TSB110277
-----------

Signature™, QSX, and ISX CM570/CM870/CM871/CM2250 Replacement Cylinder Liner Compatibility

Figure 1, Location of Measurement

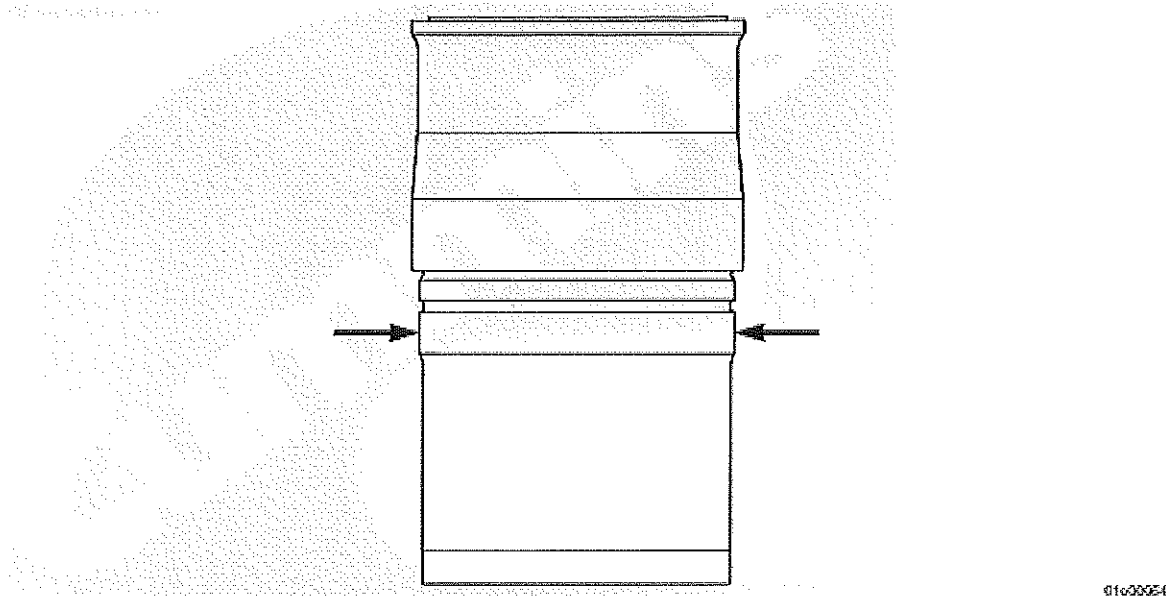
Before replacing a flat top designed cylinder liner, verify the size of the cylinder liner presently installed on the engine. The correct cylinder liner can be determined by measuring the outside diameter of the cylinder liner at the cylinder liner o-ring packing area. For a groove top design cylinder liner, the verification is **not** needed when replacing a groove top cylinder liner with

another groove top cylinder liner. See Figure 1 for the location where the measurement is to be taken.

**NOTE:** A small outside diameter cylinder liner will visually appear to have been correctly installed into a large bore cylinder block. However, because of the smaller outside diameter of the cylinder liner, it will fit loosely into the cylinder block at the cylinder liner o-ring sealing area. This will result in excessive cylinder liner movement in the cylinder block.

Once the size of the cylinder liner has been determined, refer to the table below for the correct cylinder liner part number.

Cylinder Liner and Kit Part Number		
Liner Outside Diameter (OD)	Cylinder Liner	Cylinder Liner Kit
150 mm [5.906 in]	4311633	4309389
152 mm [5.984 in]	3685235	2881719
